PEACH BOTTOM ATOMIC POWER STATION, UNIT NO. 3

AMENDMENT TO FACILITY OPERATING LICENSE

Amendment No. 92
License No. DPR-56

SAFETY EVALUATION BY THE OFFICE OF NUCLEAR REACTOR REGULATION
SUPPORTING AMENDMENT NO. 92 TO FACILITY LICENSE NO. DPR-56

FIGURE 3.5.K. MCPR OPERATING LIMIT vs T

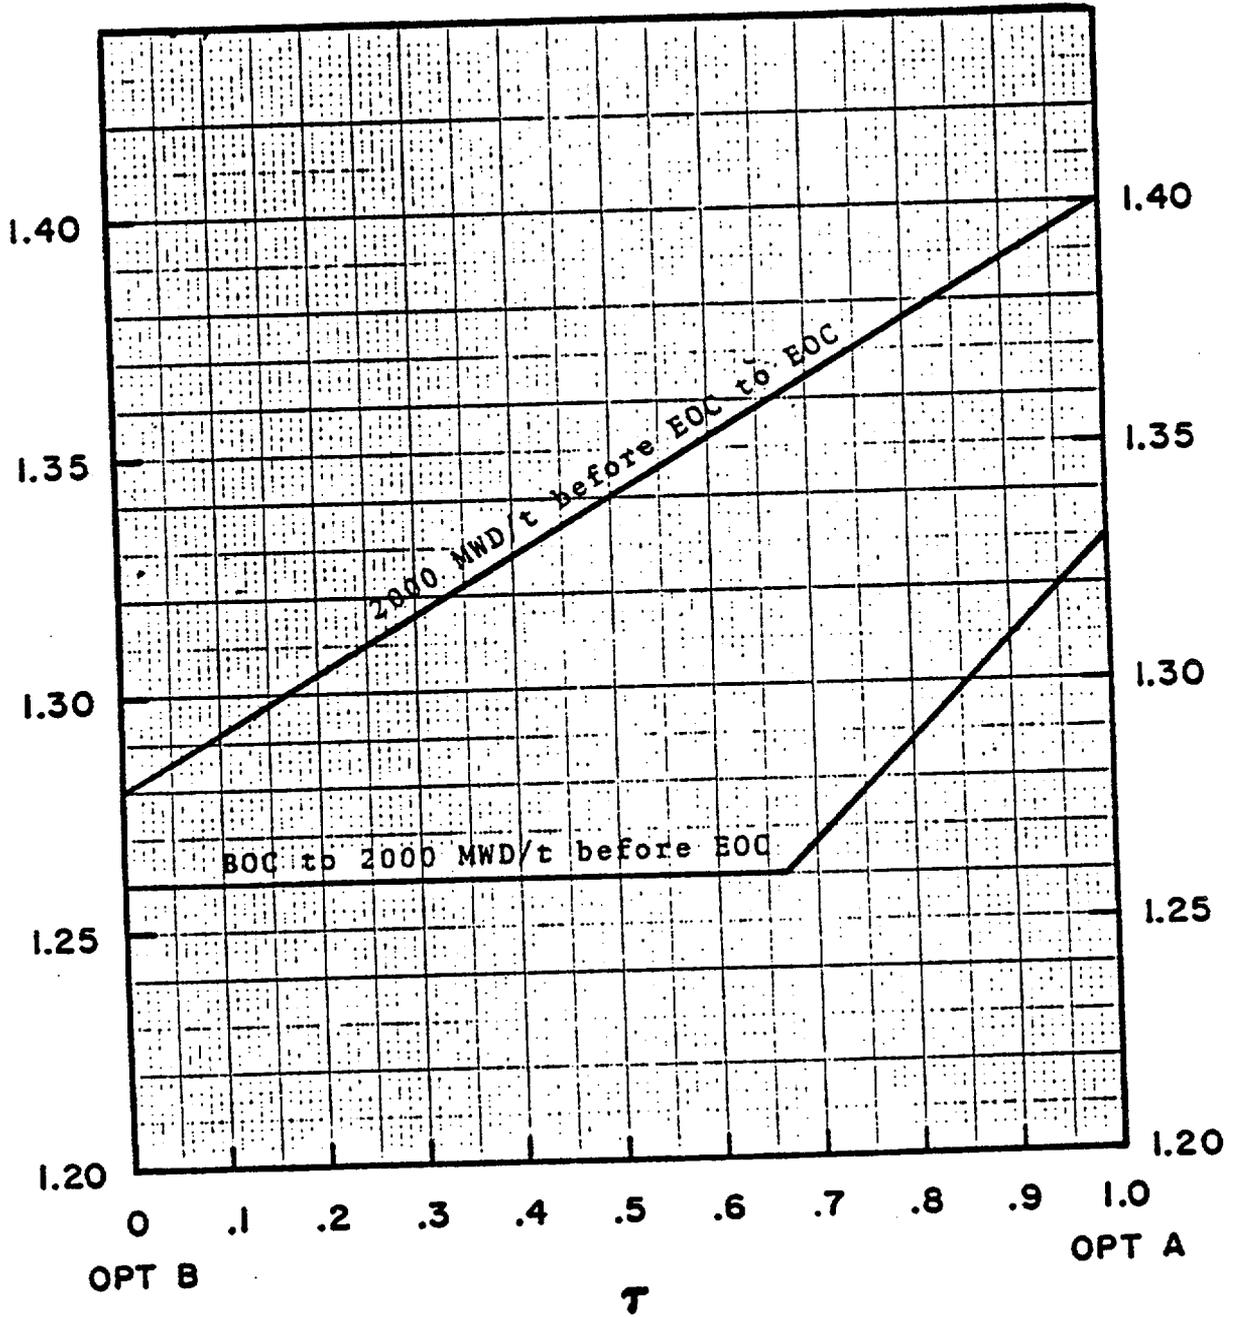
Figures 3.5.K.1, 3.5.K.2 and Tables 3.5.K.2, 3.5.K.3 of the TSs have been modified to include the operating limit MCPRs for Cycle 6 operation. Using Option A, the operating limit MCPRs would be 1.33 for Cycle 6 fuels at burnup conditions from BOC to 2000 MWD/t before EOC, and 1.39 for PTA, P8X8R fuel types and 1.40 for LTA at burnup conditions from 2000 MWD/t before EOC to EOC. Using Option B, the operating limit MCPRs would be 1.26 for Cycle 6 fuels at burnup conditions from BOC to 2000 MWD/t before EOC, and 1.27 for PTA, P8X8R fuel types and 1.28 for LTA at burnup conditions from 2000 MWD/t before EOC to EOC.

FIGURE 3.5.1.k MAXIMUM AVERAGE PLANAR LINEAR HEAT GENERATION RATE VERSUS PLANAR AVERAGE EXPOSURE

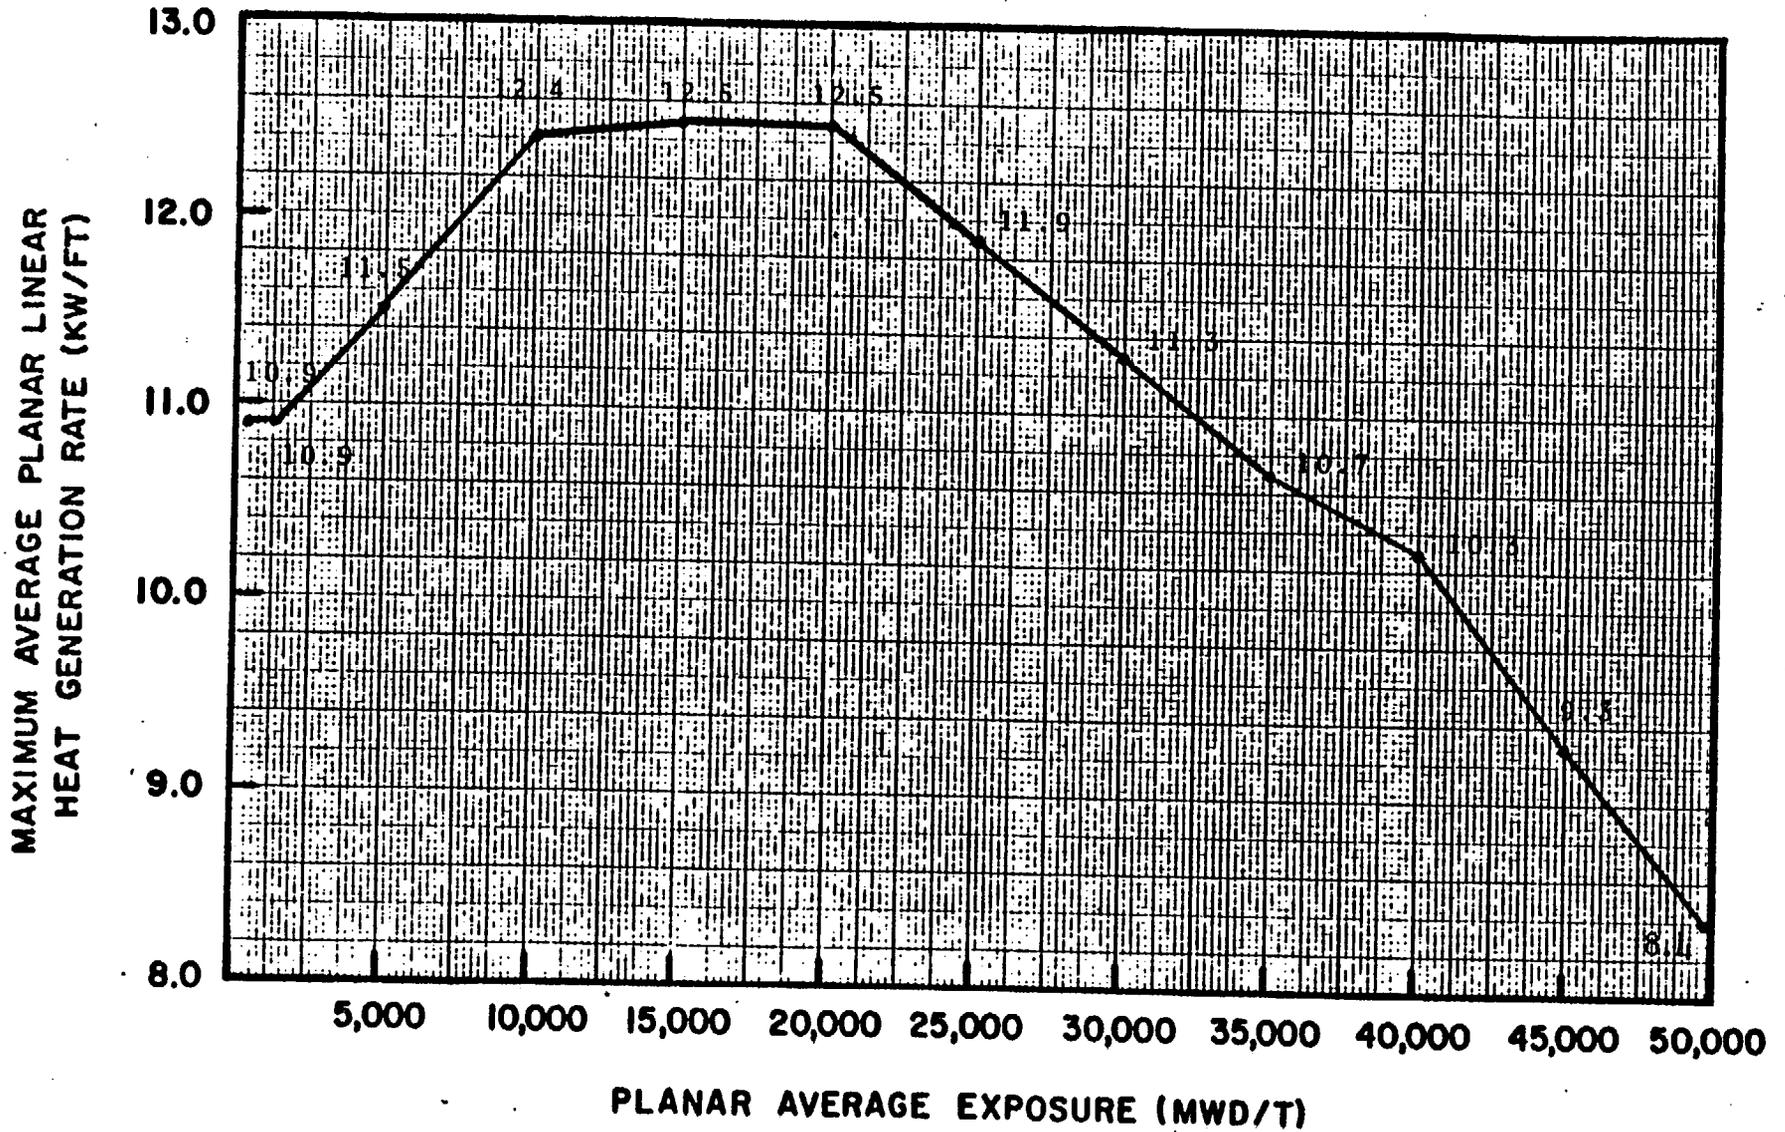
Analyses of the safety considerations involved in the proposed MAPLHGR limits for the four LTAs and extended exposure limits for the one PTA are provided in References 4 and 5. Although the methodology used is generally applicable for these limits, we believe that the effects of enhanced fission gas release in high burnup fuel (above 20 MWd/kgU) were not adequately considered in the generic analysis. In response to this concern, GE requested (Refs. 9 and 10) that credit for approved, but unapplied, emergency core cooling system (ECCS) evaluation model changes, and calculated PCT margin, be used to avoid MAPLHGR penalties at higher burnup. This proposal was found acceptable (Ref. 11) provided that certain plant-specific conditions were met. PECO has stated (Ref. 12) that the GE proposal is applicable to both Peach Bottom Units 2 and 3. On the basis of this finding, we conclude that the MAPLHGR limits proposed for Peach Bottom 3 Cycle 6 are acceptable.
